To: Hilary Saunders < h.saunders@northyorkmoors.org.uk > Subject: Balconies, Hogarth Hall - NYM/2020/0420/FL

I am pleased to forward you amended plans introducing lightweight external staircases to serve the proposed balconies in the current application and one for the previously approved balcony (approved under NYM/2019/095/FL) as discussed:

Froposed Staircase at First Floor Plan

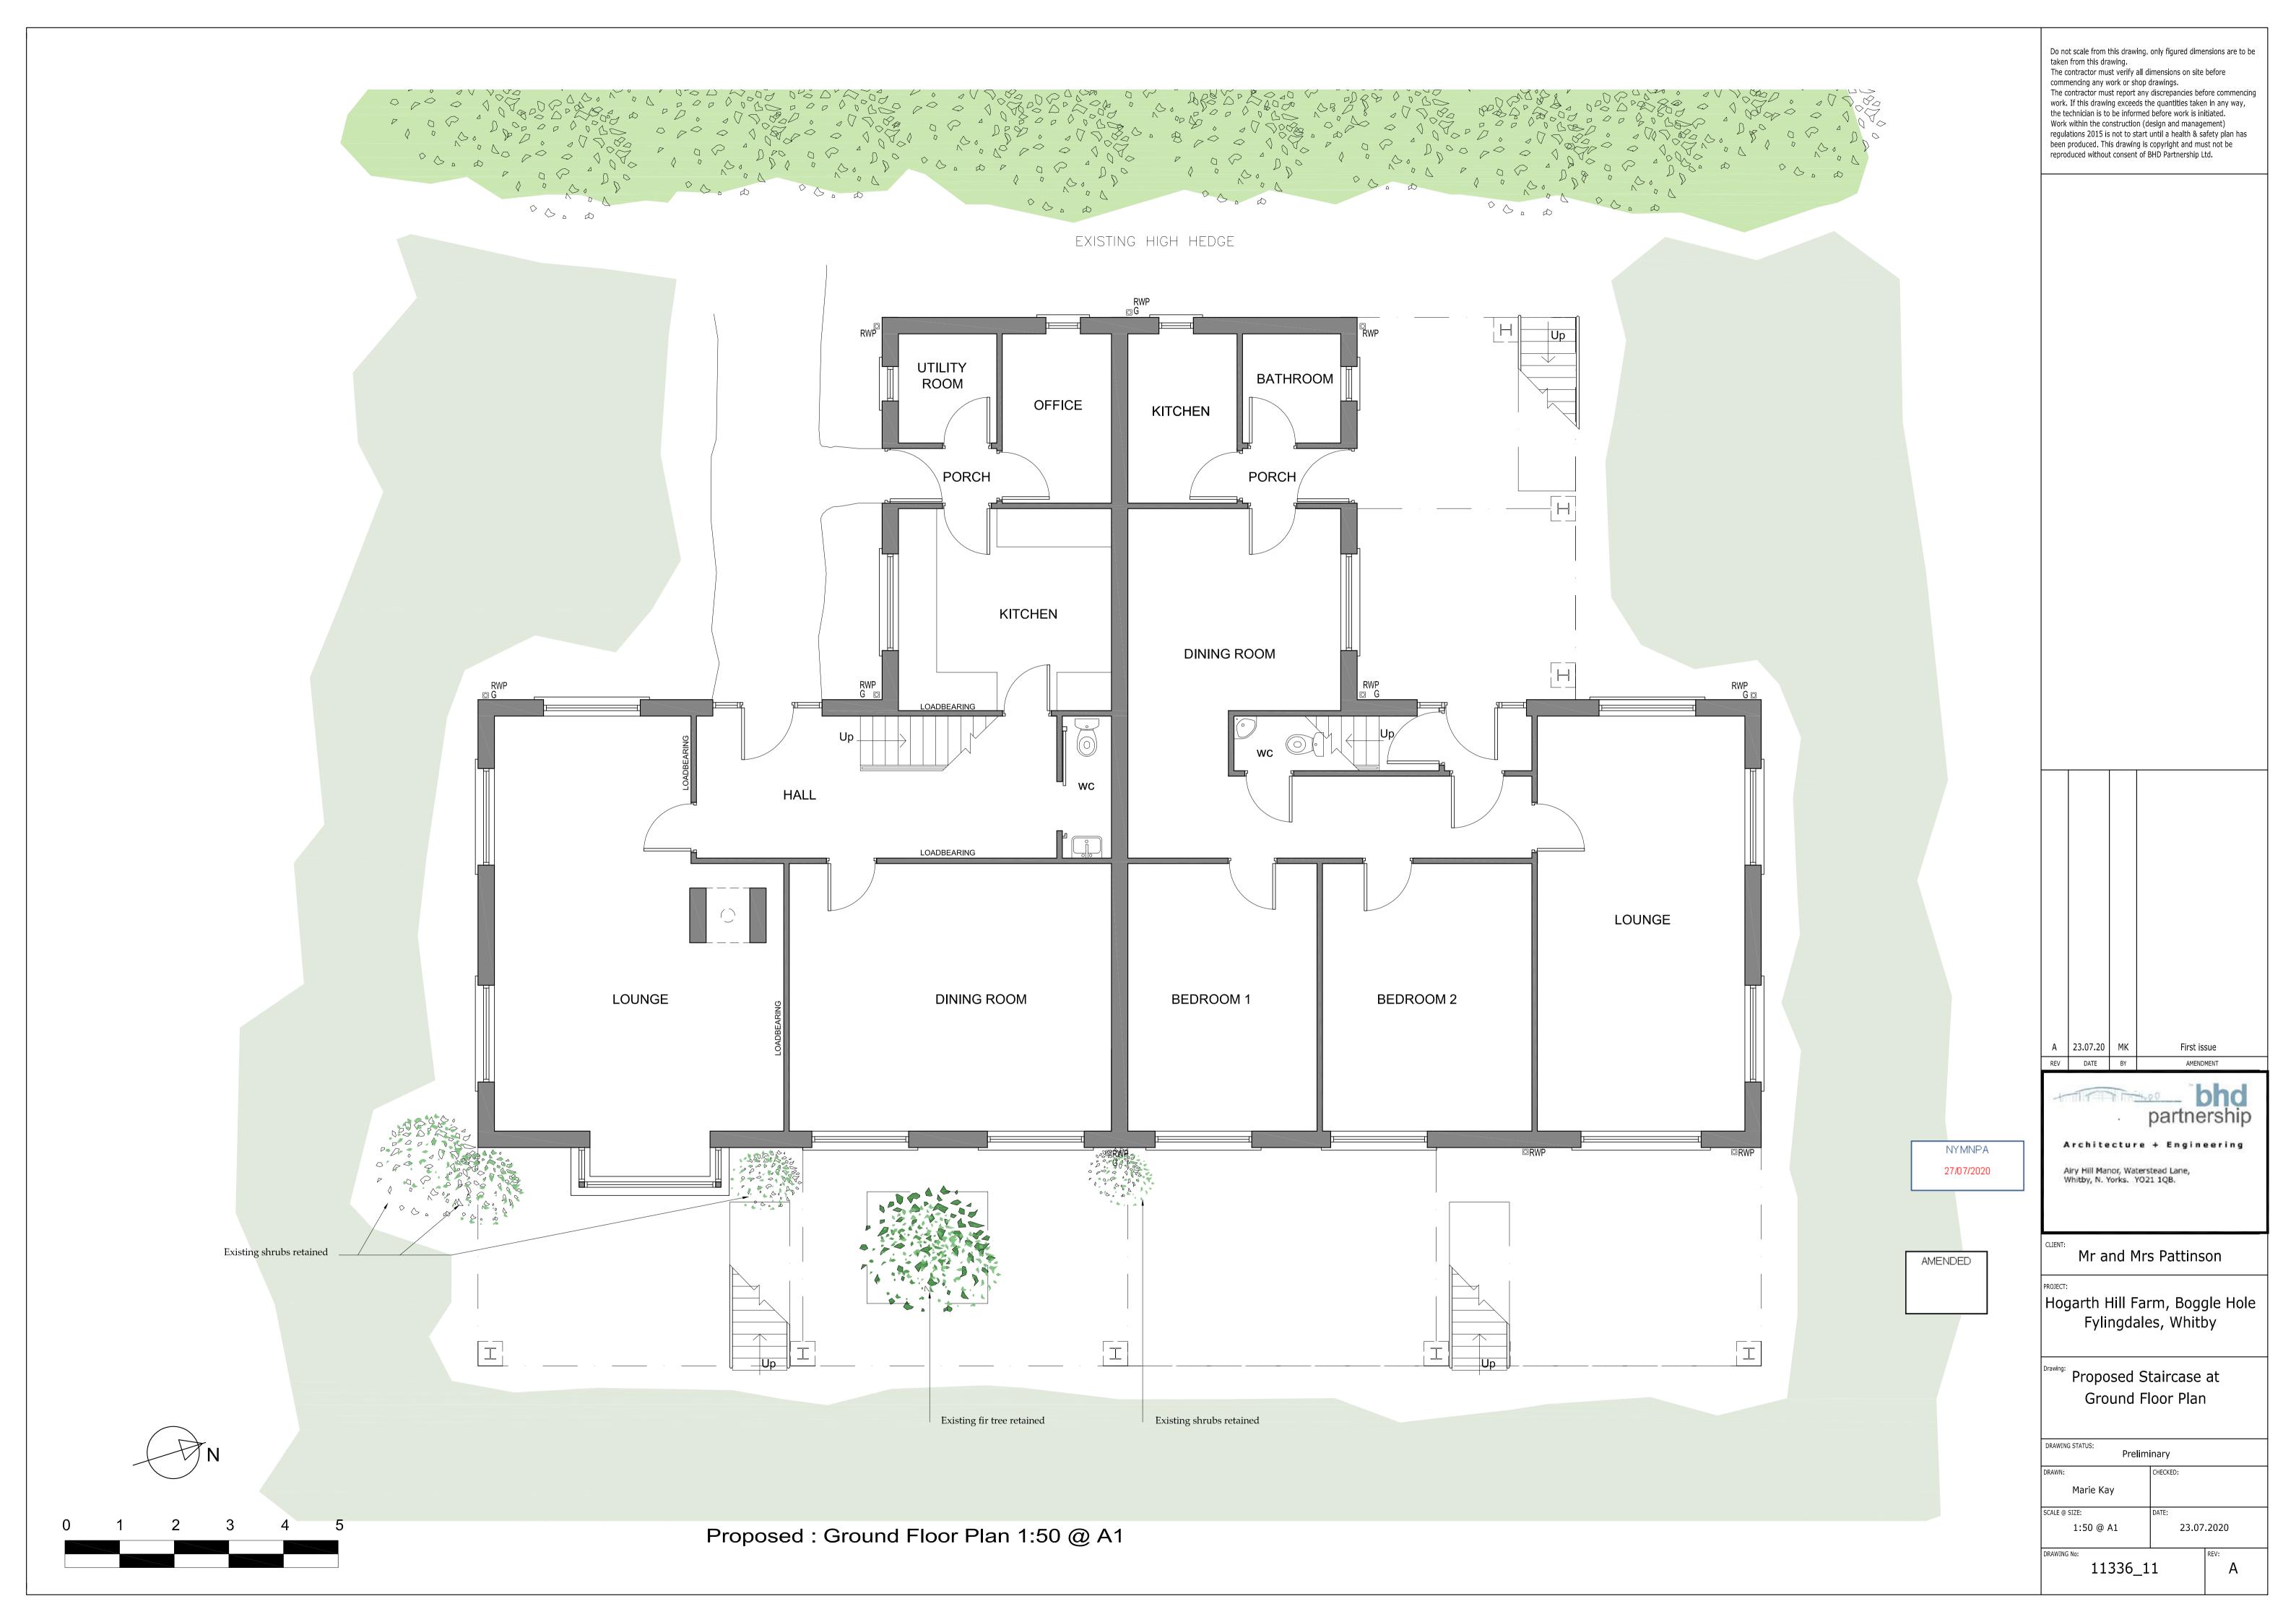
- Proposed staircase at ground floor plan 1136 11 A.
- Proposed staircase at first floor plan 11336_12 A.
- Proposed staircase to west and south elevations 1136_13 A.
- Proposed staircase rear (east) and side (north) elevation 11336_14 A
